**McCARTY COMMONS
INTERSTATE HIGHWAY 35/McCARTY LANE SEC
PLANNED DEVELOPMENT (PD) DISTRICT
DEVELOPMENT STANDARDS**

Amended and Restated INSERT DATE ~~May 21, 2013~~

**Note on 2026 amendment – the proposed changes to this document have been requested by
HEB, LP, who now own part of the property within the District Boundary.**

10 SITE PLAN
SCALE: NTS

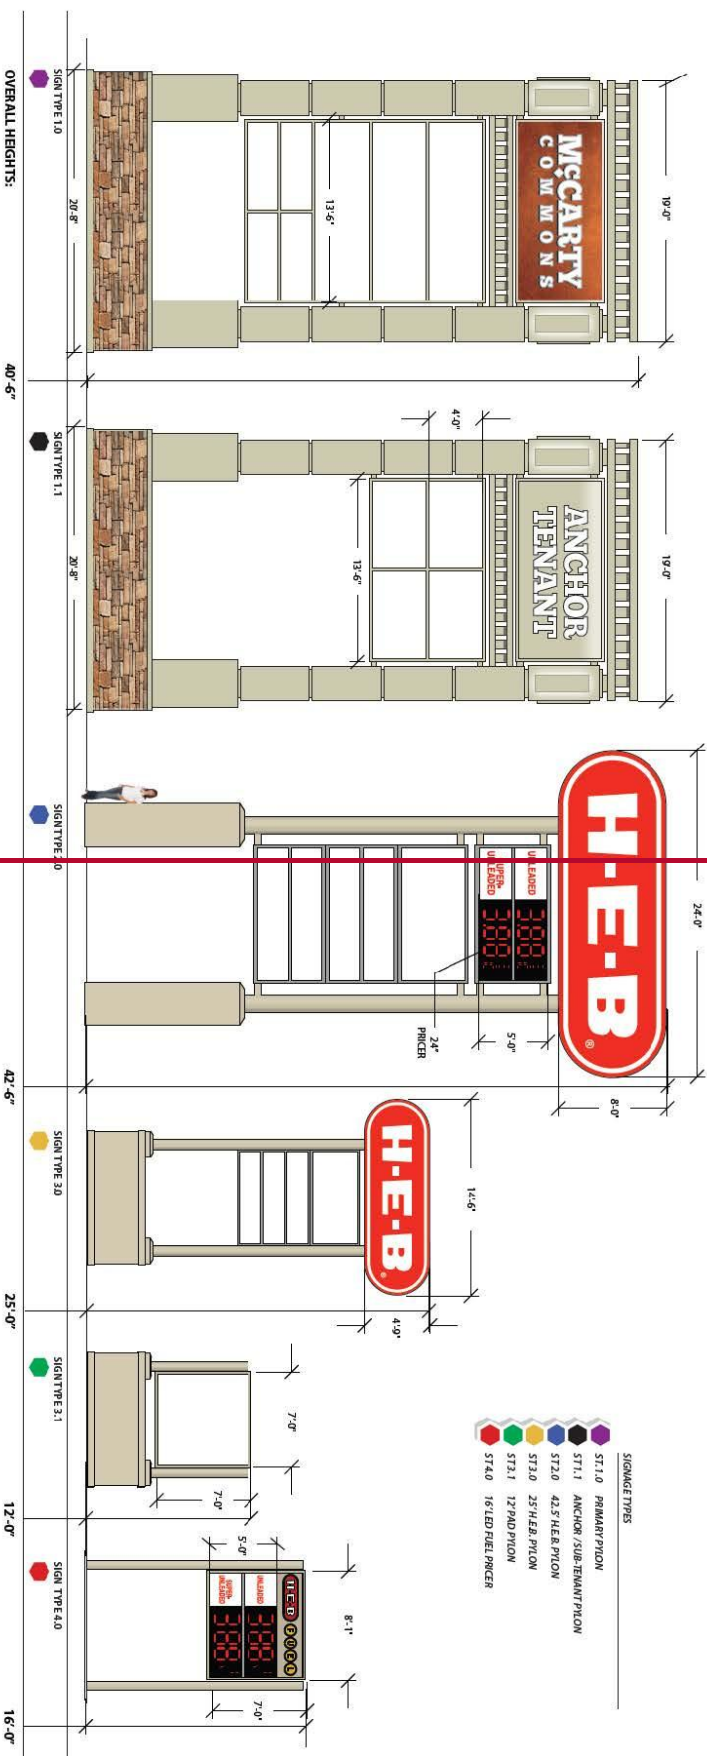
Staff Note: This page removed
